IPC Submission - Appendix

I, Liz Watts, object to the Hills of Gold Wind Farm (SSD - 9679).

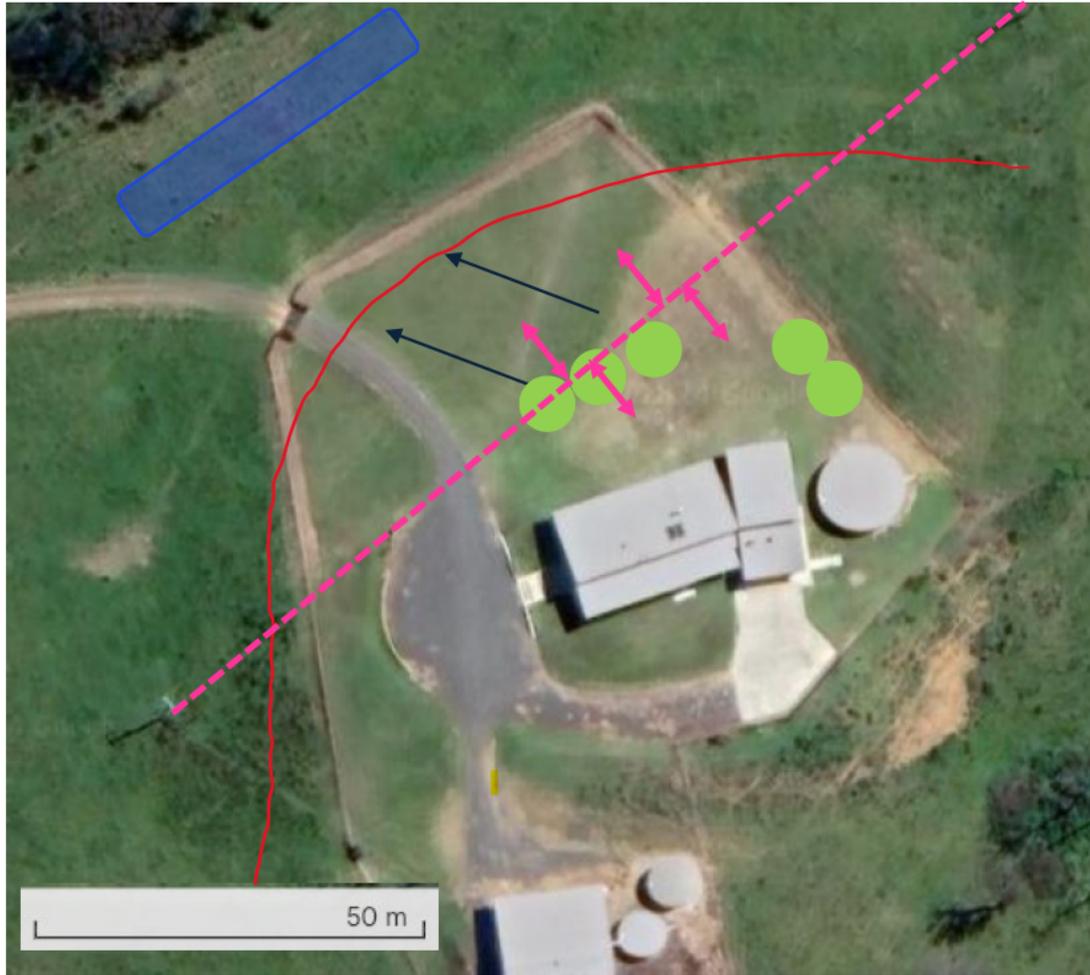
Proposed mitigation is not reasonable nor feasible

2. The secondary mitigation proposed by Engie is to provide vegetative screening which is likely to start reducing potential impacts in 5-7 years of plant establishment. This proposed planting would not occur until after construction of the project. What this mitigation fails to appreciate is that vegetative screening is neither reasonable nor feasible due to the presence of overhead powerlines, underground telecom infrastructure, the topography of the land, and bushfire management regulations. This is illustrated in the attached 'Appendix' (page 2). Furthermore, any planting which could occur to the north of the dwelling would need to reach heights of 50m or more to act as screening - the existing established trees are no more than 20m in height. Perhaps the proponent suggests we plant sequoias?
